Title	Parts and Version Change – Water Supply and Drainage Components		
Create Date	February 2, 2017	Service Bulletin Number	ASC20170202001
Revision Date	May 1, 2017	Model: DW80J3020US/AA DW80J3020UB/AA DW80J3020UW/AA	Dishwasher
Symptom	Update	Version Change	Incompatible Parts

Old (No version on S/N)	New (Version 01 on S/N)

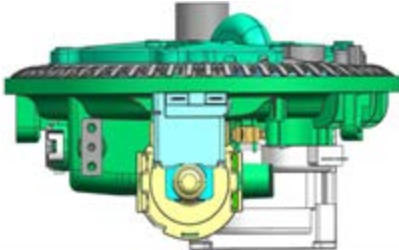
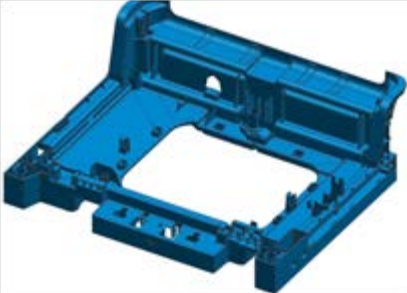
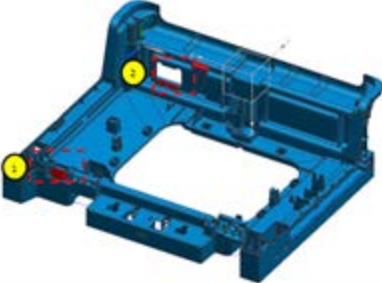
Parts which are related to water supply and drainage were changed to resolve water leakage and drain problems. New versions of the dishwashers (Ver 01) with the new parts were put into production in December, 2016 and January, 2017.

Several of the new parts are not compatible with the old model. All new versions of these dishwashers have 01 after the model number on the Model Number/Serial Number plate. Old versions do not. See above. Please make sure you order parts for the correct version. See the tables below for the parts and part numbers by version.

Parts Information :

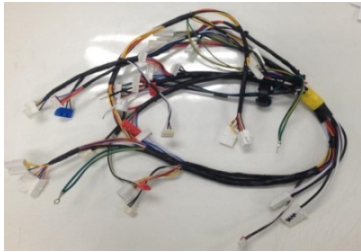
Part Name	Old (No version on S/N)	New (Version 01 on S/N)
Case Sump	DD81-01493C	DD81-01493D

PLATE BASE	DD61-00295A	DD61-00295B

VALVE WATER	DD62-00084A	DC62-30314L
